Location: 1300 W. 11th Ave. (Head in Area)

APPLICATION FOR PERMIT

For excavation and foundation only for 1 1/2-story frame dwelling 36' x 24'6" with attached two car garage 22' x 22'

A.P. 23 Abby Lane (Crest View Acres)

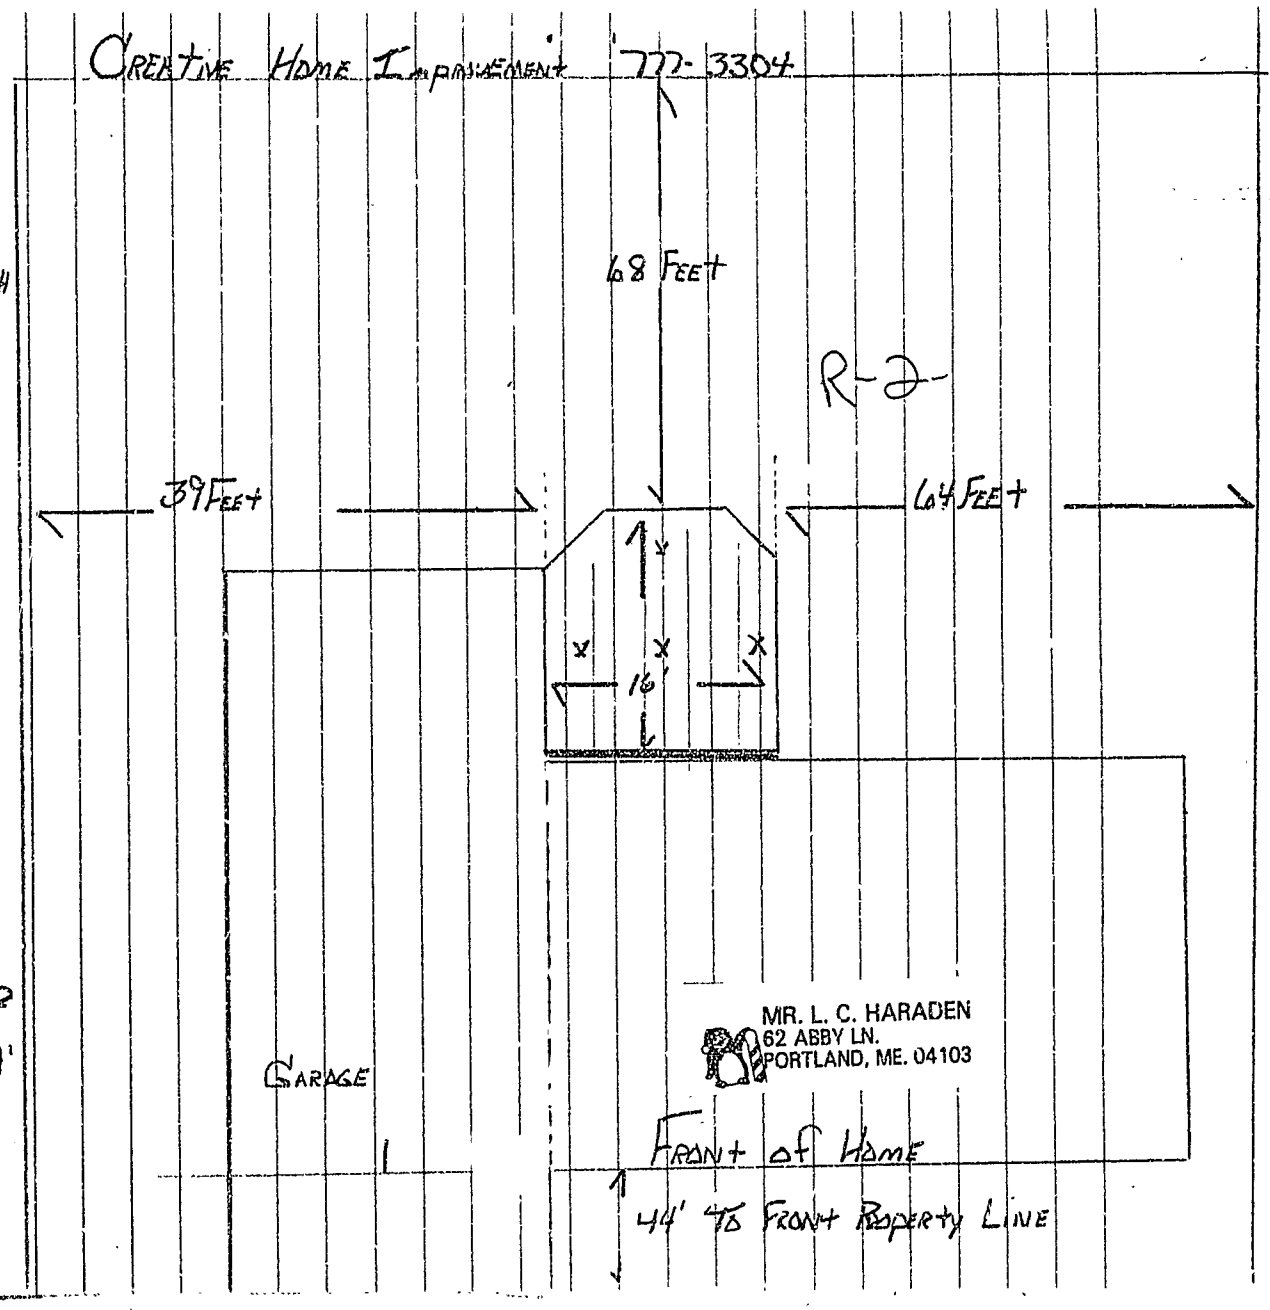
X 9.) A guardrail system located near the open side of deck or elevated walking surfaces shall be constructed. Guards in buildings of Use Group R-3 shall be not less than 36 inches in height. Open guards shall have intermediate rails, balusters or other construction such that a sphere with a diameter of 4 inches cannot pass through any opening.

X = PISTOL FOR  
DECK  
Some tubes 4'  
below grade
